Appendix B -- Seismic Background and Analysis

Independent Review EAC 2005

Figure 1 Horizontal Response Spectra Comparison including the April 1, 2005, Interim Seismic Criteria

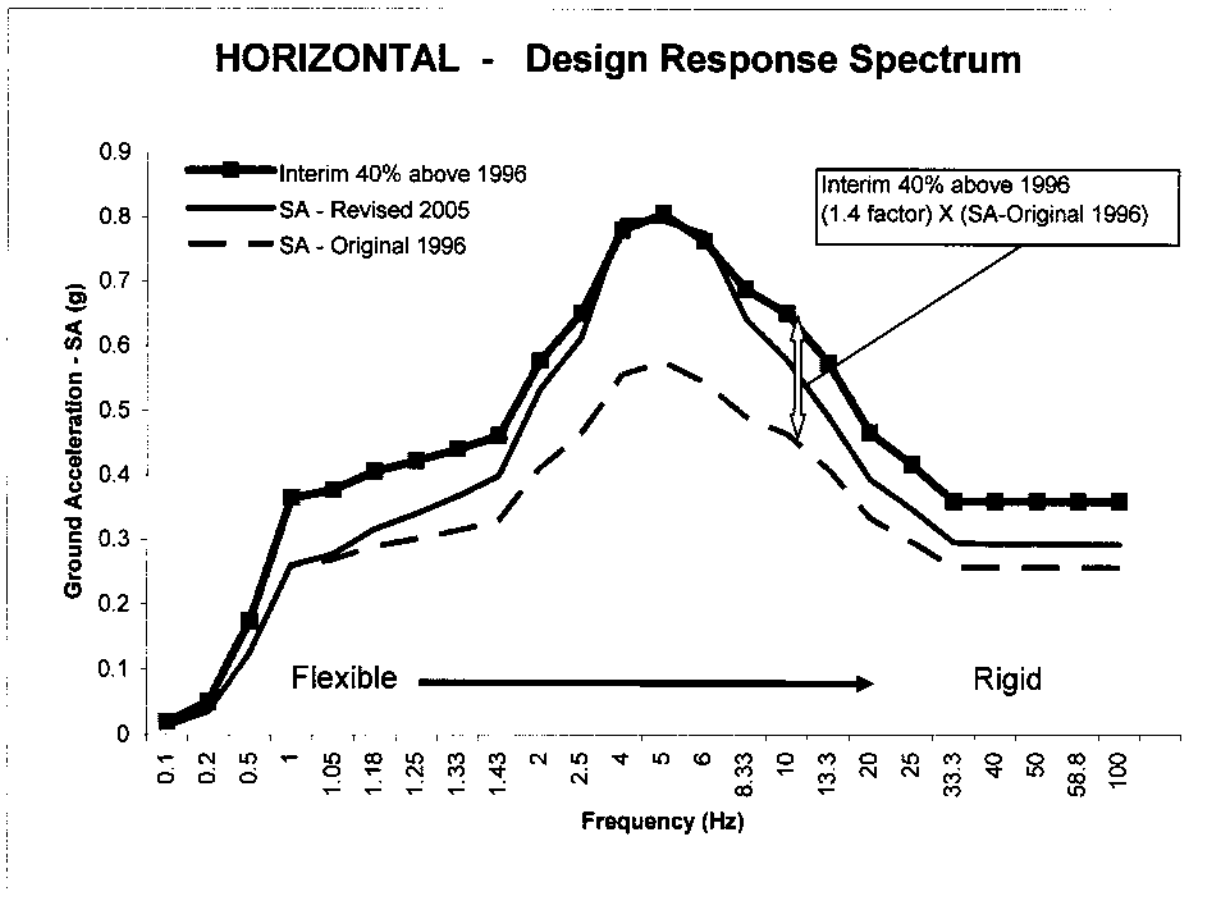
After receiving a written request from the DOE-ORP, BNI developed recommended interim seismic criteria to be used prior to the completion of updating structural modeling, based on the revised ground motion, and submitted these criteria to DOE-ORP on March 8, 2005. DOE-ORP reviewed and modified the interim seismic criteria and provided the approved “Interim Seismic Criteria” to BNI on April 1, 2005, which states: “The acceleration is increased by 40 percent in the 4-7 Hz range, and to a smaller magnitude outside this range. Assessment of the seismic analysis is that the magnitude of increase in loading for the SSCs for most of the cases would be at least 5 to 10 percent less than the assumed 40% increase in the peak seismic accelerations.¹²” Figure 2 illustrates that there are a significant number of situations where the magnitude of loading increase is likely to be less than the 40% maximum increase.

Figure 3 Selected Seismic Correspondence Timeline

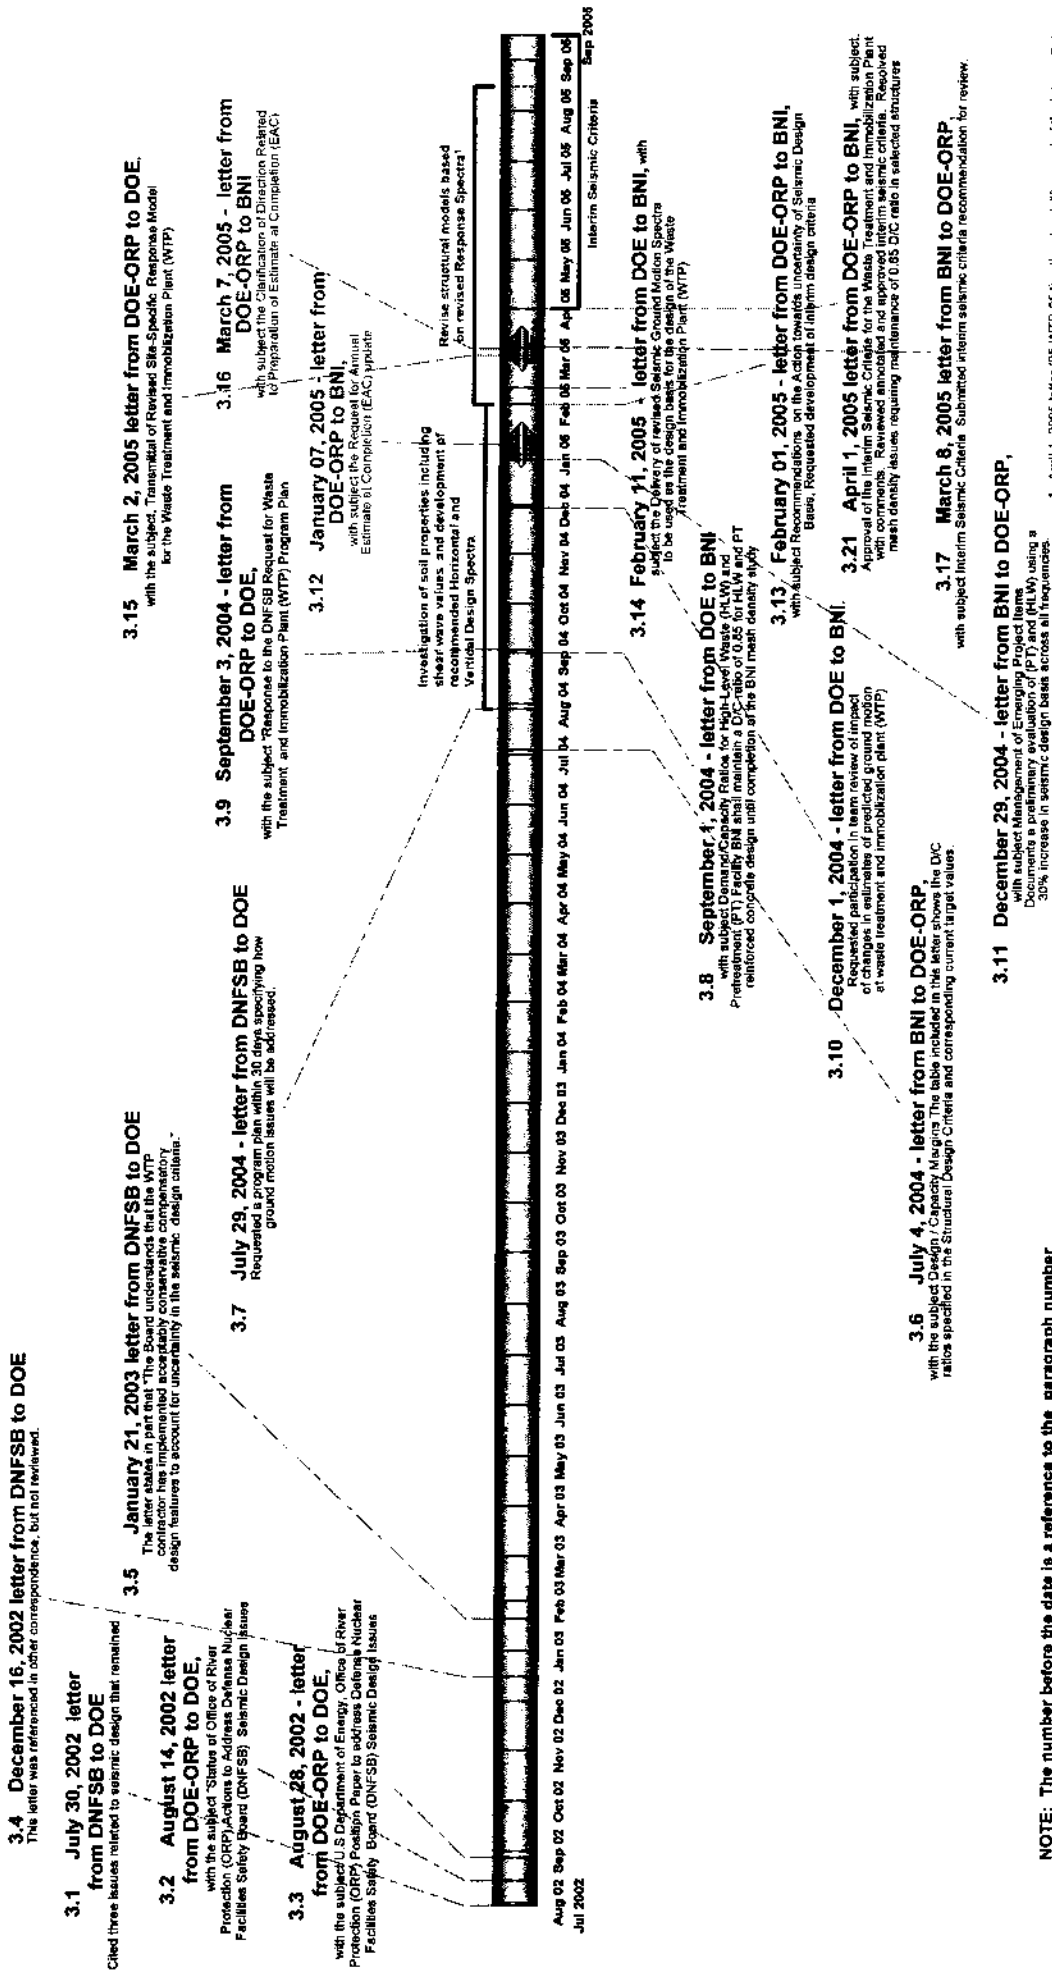
The correspondence chain (figure 3) shows that DOE-ORP was proactive in notifying BNI of potential changes and requesting assessment of impacts in December 2004 prior to the finalization of the changes to the design response spectra (February 2005).

FIGURE 6. Layering of Design Margins or Conservatisms in HLW Facility

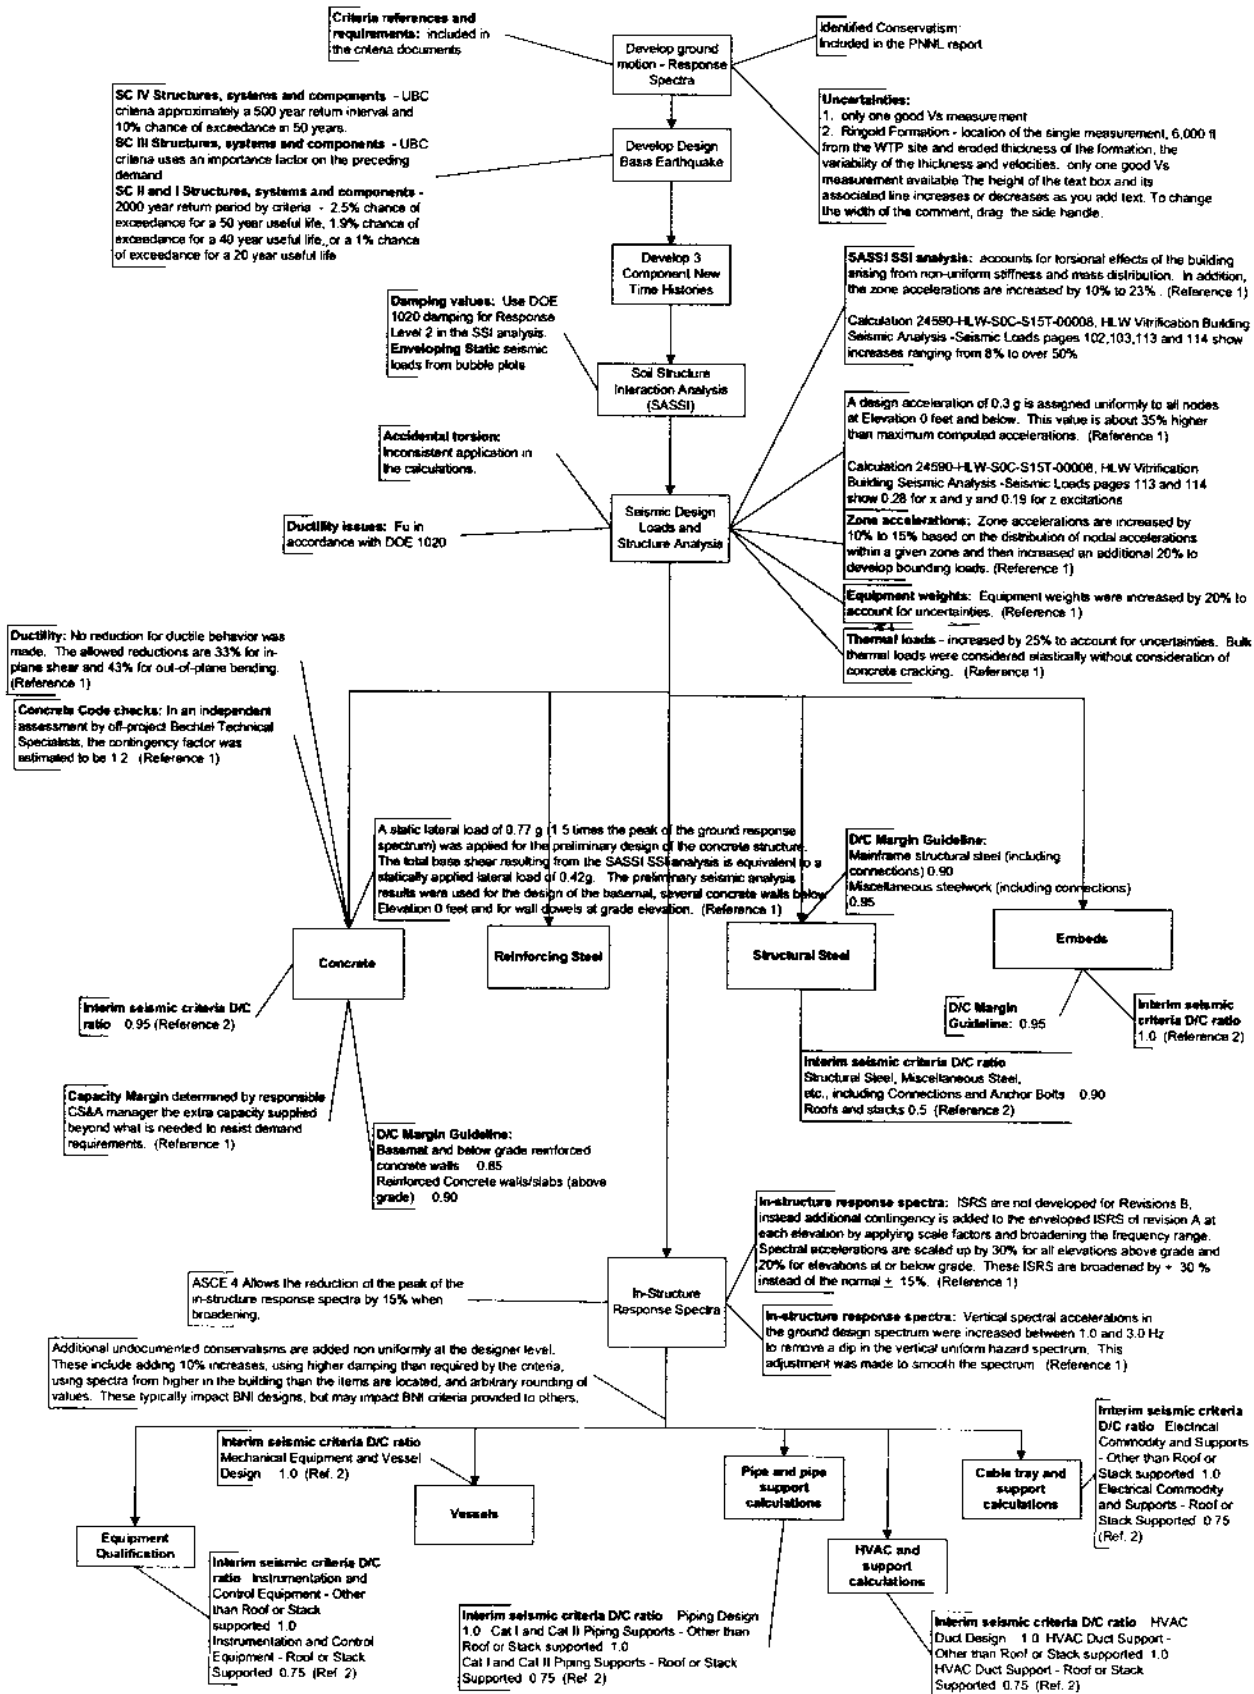
There is no documented approach to address and manage the existing design margins used through the design process. The design margins include more conservatism that is shown by the Demand / Capacity ratios. Conservatism is introduced at many levels during the design (see figure 6).
